VILLAGE OF ROYAL PALM BEACH, FLORIDA

PROJECT NAME: COMMONS PARK PATHWAY LIGHTING  
PROJECT NUMBER: PR1903

**ADDENDUM NUMBER: FIVE**

DATE OF ISSUANCE: September 28, 2021

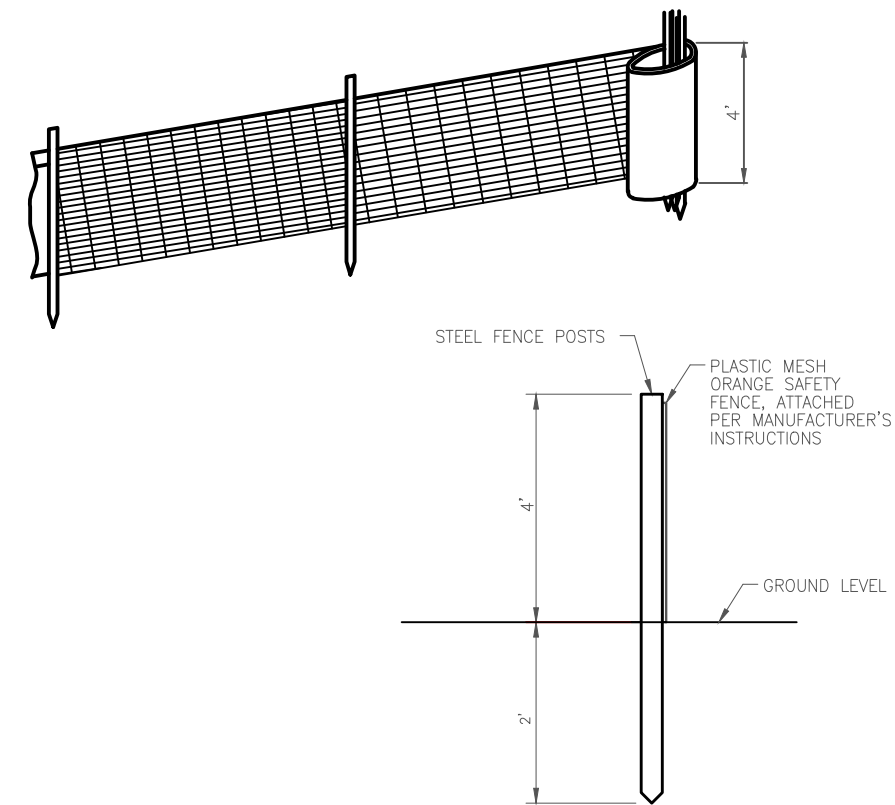
Addendum 5 Revisions:  
Alternative entrances for Wednesday mornings have been added.

DATE: AUGUST 2021  
SHEET: E-2 OF 25

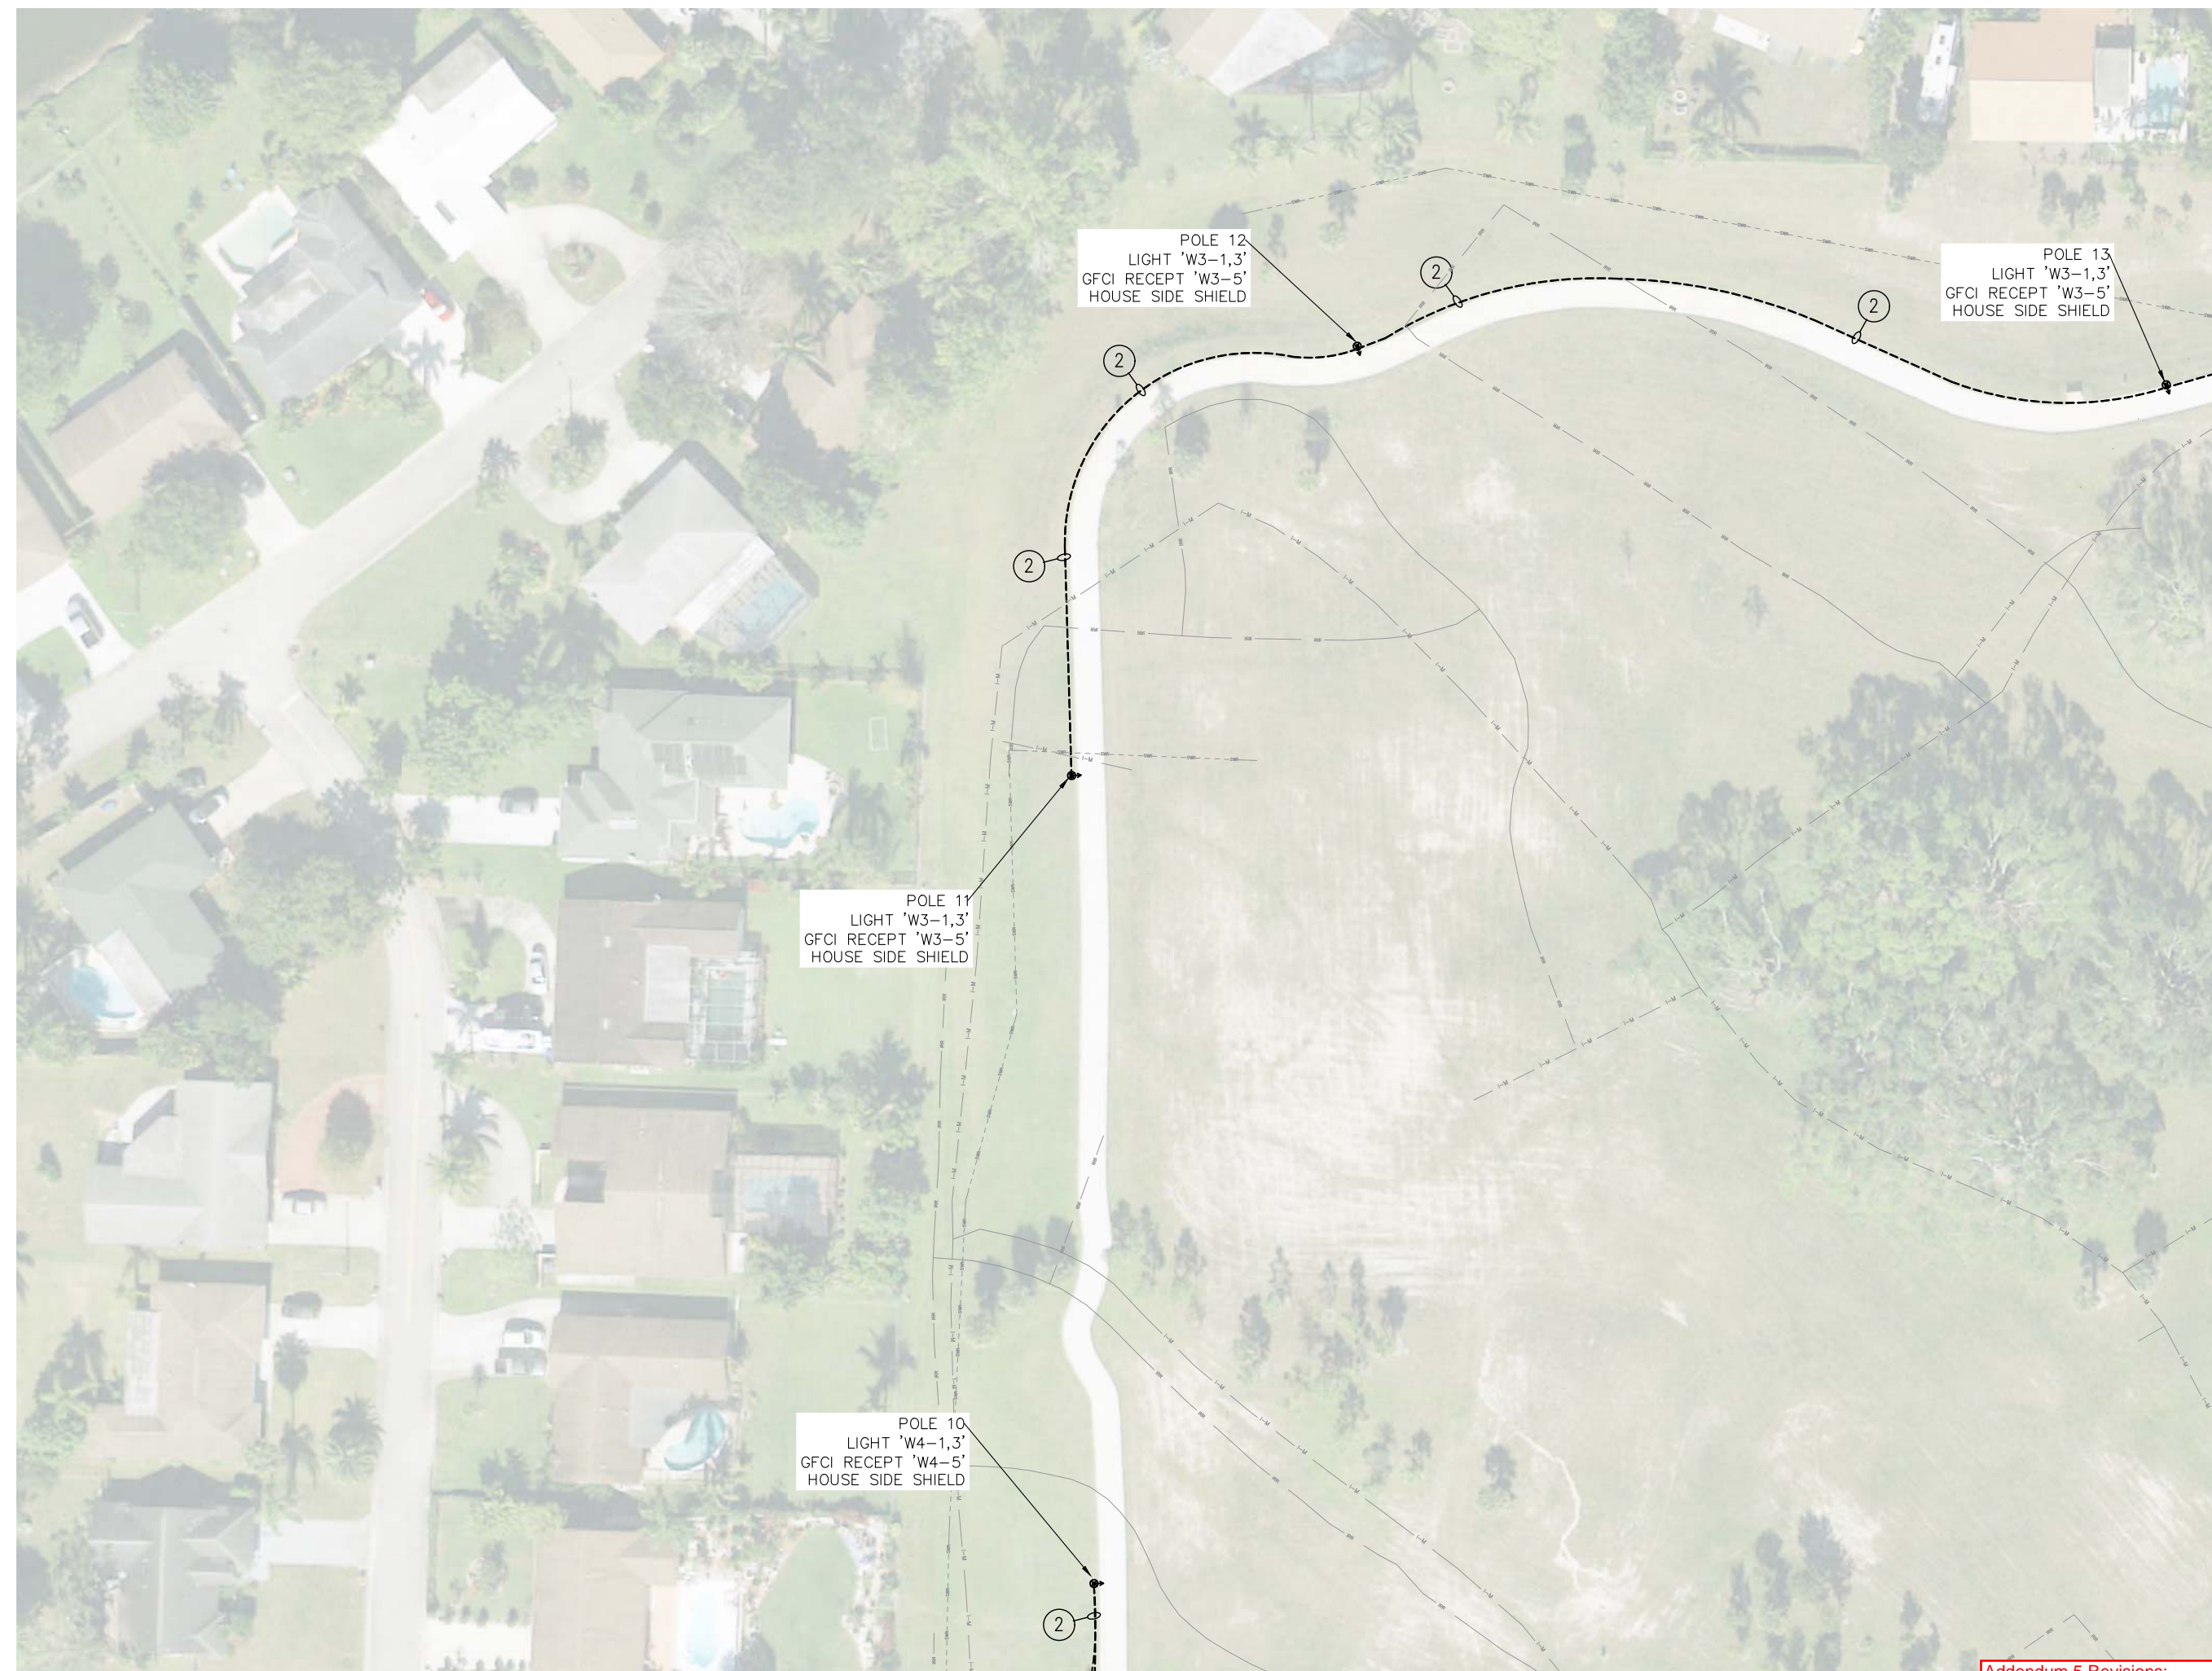
Addendum 5 Revisions:  
Minor spelling and visual corrections; Key Note 5 updated; Key Notes 14-17 added; Added Symbol Legend; Intermediate pull boxes in the middle of each run between proposed poles have been removed.

DATE: AUGUST 2021  
SHEET: E-5 OF 25

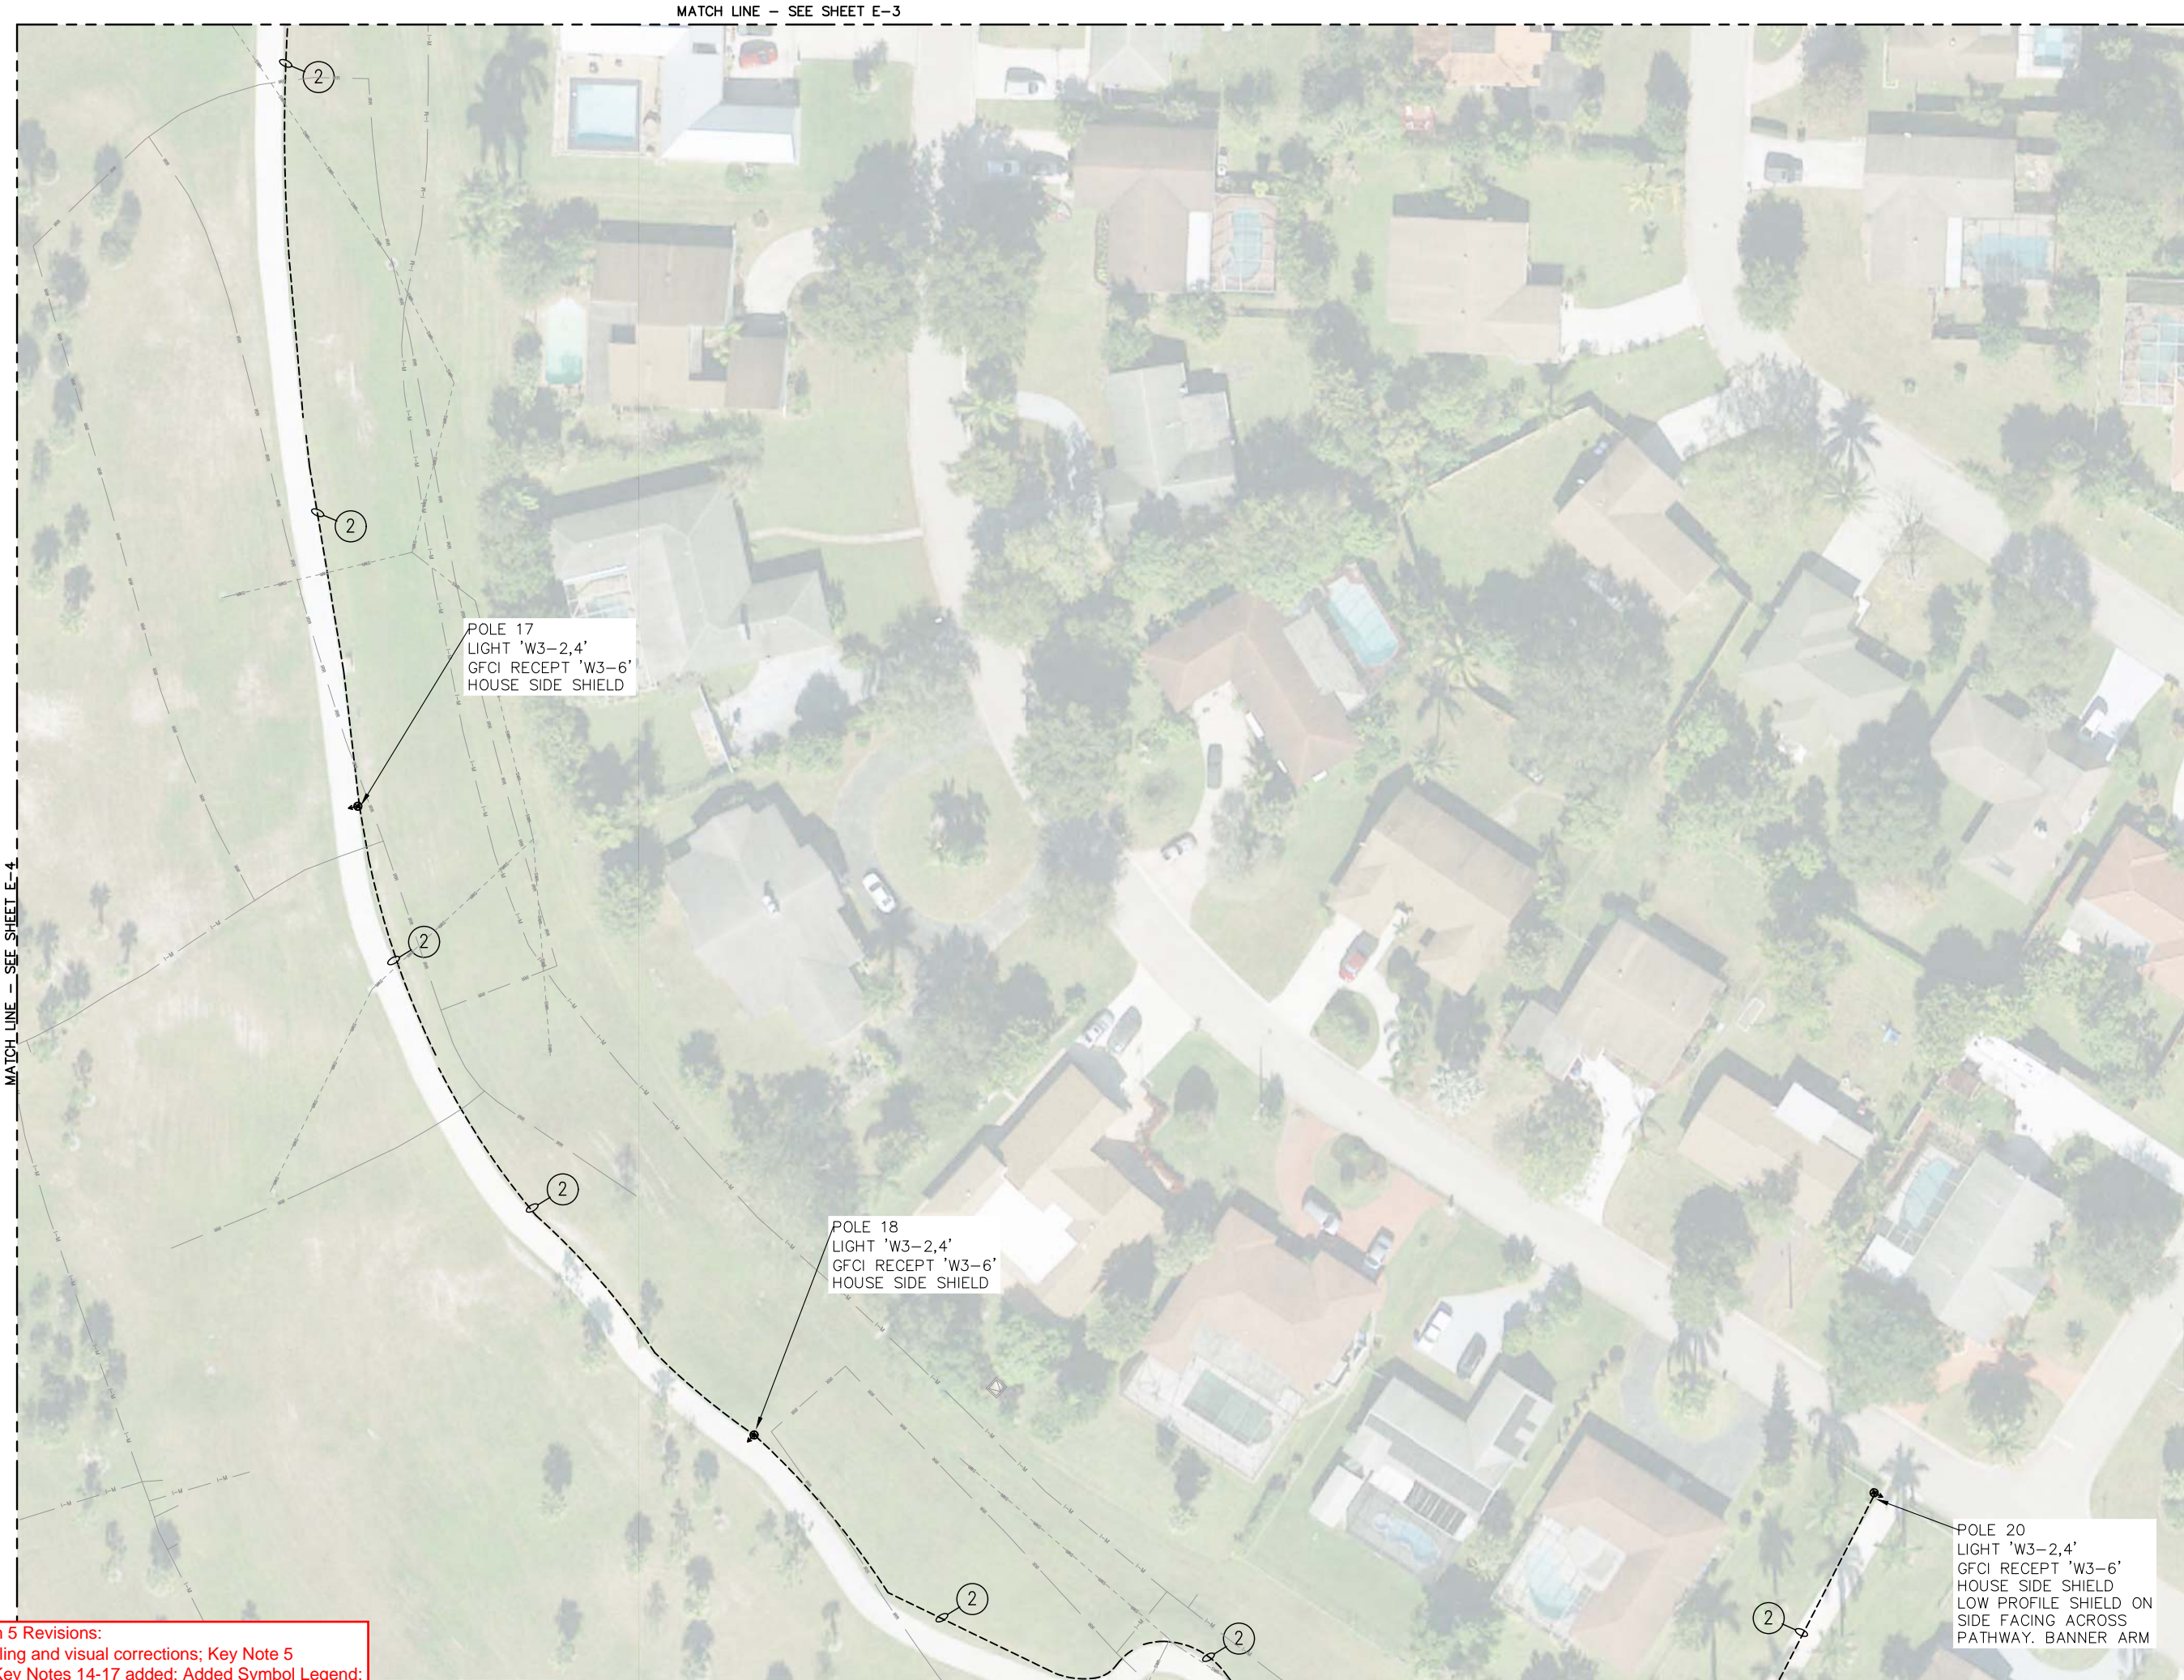
**Addendum 5 Revisions:**  
Minor spelling and visual corrections; Key Note 5 updated; Key Notes 14-17 added; Added Symbol Legend; Intermediate pull boxes in the middle of each run between proposed poles have been removed.
